CONTRACT #72541

ILLINOIS DEPARTMENT OF TRANSPORTATION
INDEX OF SHEETS & STANDARDS
FAI-72, MACARTHUR BLVD
SEC NO. 02-00382-02-PV
SEC NO. (84-9-4)A,HBK,BY,BY-1
SANGAMON COUNTY, ILLINOIS

2 REV. 3-2-07

**CONCRETE PARAPET
SLIPFORMING OPTION**

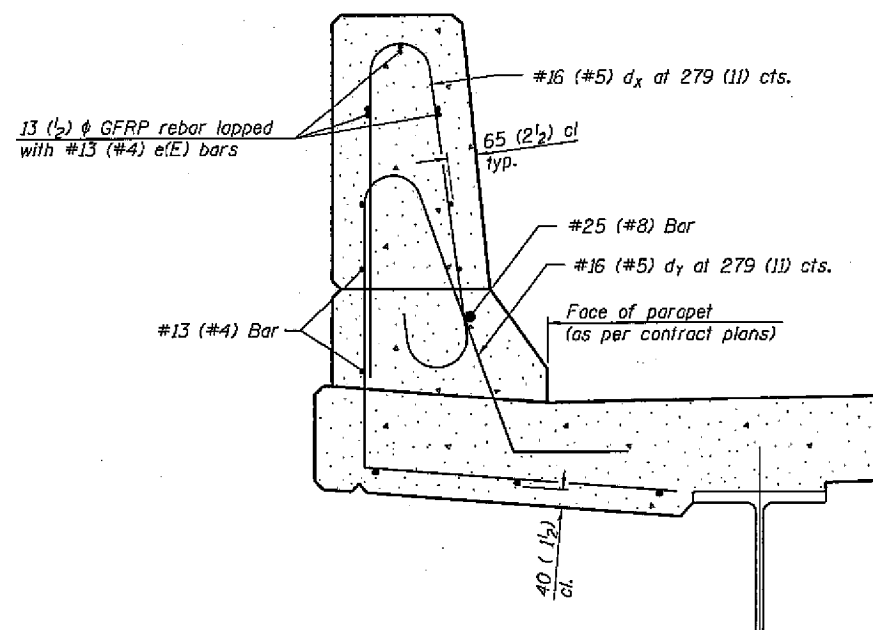
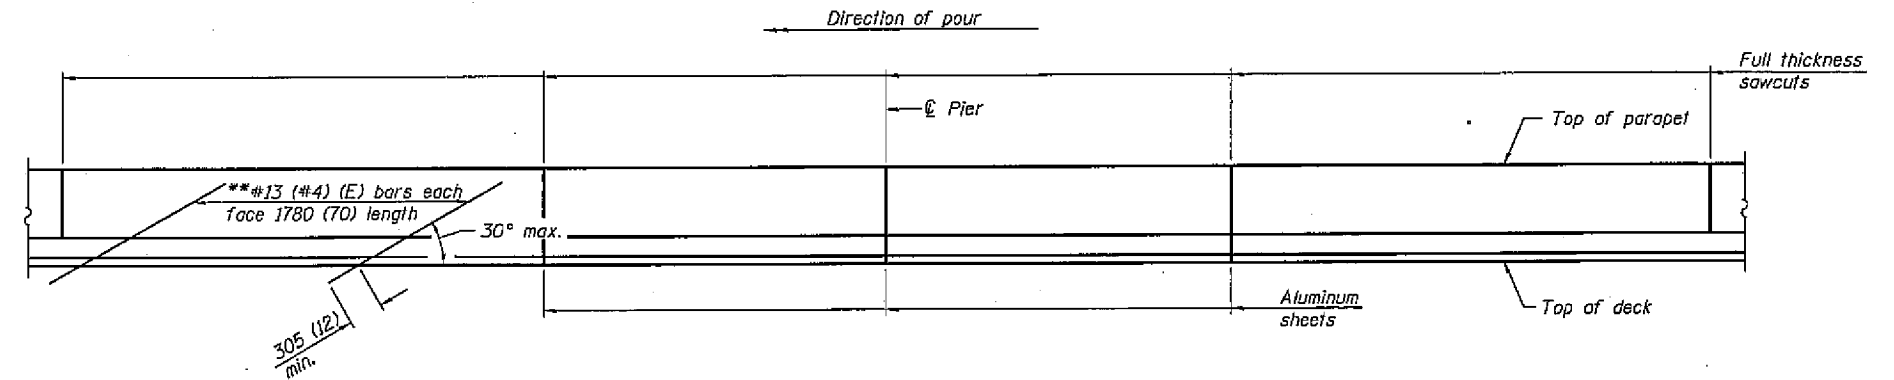
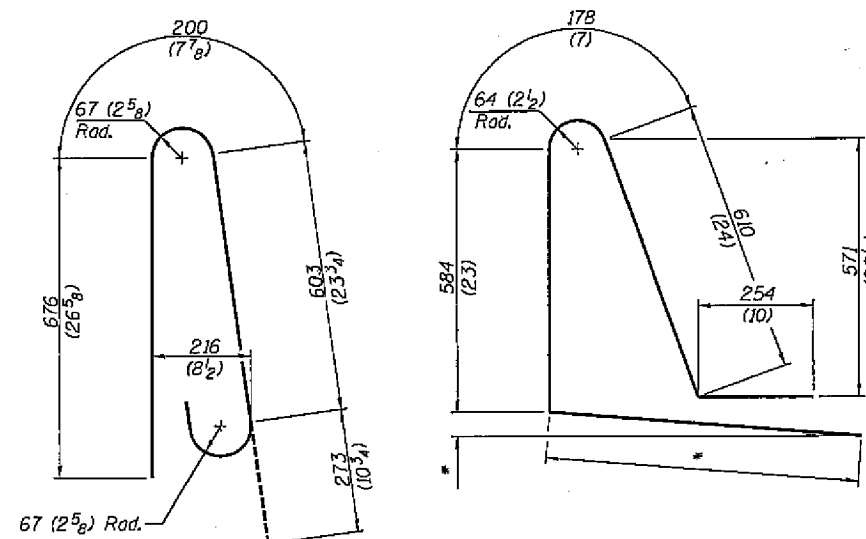
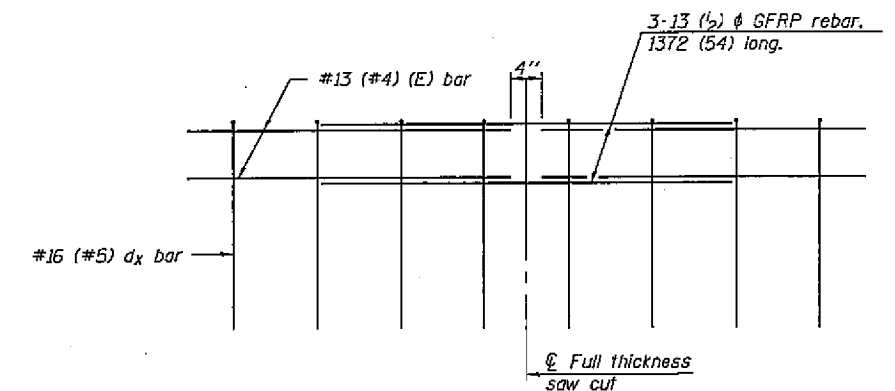
All dimensions shall remain the same as shown on contract plans, except dimensions A and B which are to be revised as shown to provide additional clearance. Additional concrete needed to revise dimension A and B = 0.0422 m /m (0.165 cu. yds./ft.) of parapet. Place aluminum sheet in curb portion at and near piers. Full thickness saw cut at all other locations. Adjust/add joint locations to maintain 3 to 6 meter (10 to 20 foot) spacing.
